UNITED STATES PATENT AND TRADEMARK OFFICE

10/735,440

Office Action Summary	Application No.		Applicant(s)	
	10/735,440		KOLLMANN ET AL.	
	Examiner		Art Unit	
	Charles E. Phillips		3751

SN 10/735,440
Substitute Drawing

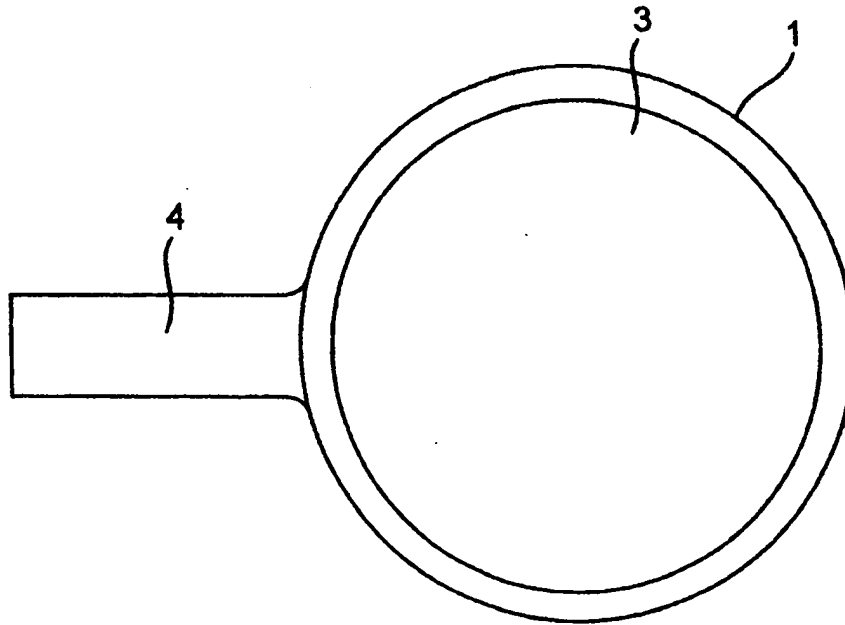
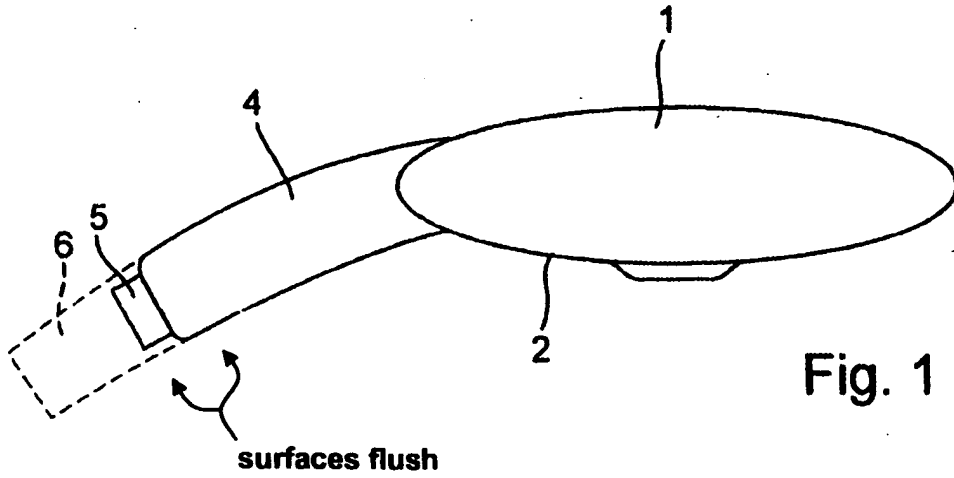
The proposed drawing correction filed on 9/28/07 is disapproved as the depiction of the union nut is inconsistent with that of the original drawings in that the double lines at the hose end are lacking, the fitting is of a different shape and the terminal end of the handle is rounded.

The drawings are objected to as being informal and for the use of a broken line showing of substance being claimed, i.e. under 37 C.F.R. 1.84(a)(4) broken lines are reserved for "alternate views". Corrected drawing sheets in compliance with 37 CFR 1.121(d) are required in reply to the Office action to avoid abandonment of the application. Any amended replacement drawing sheet should include all of the figures appearing on the immediate prior version of the sheet, even if only one figure is being

not approved
11/9/07 CEP
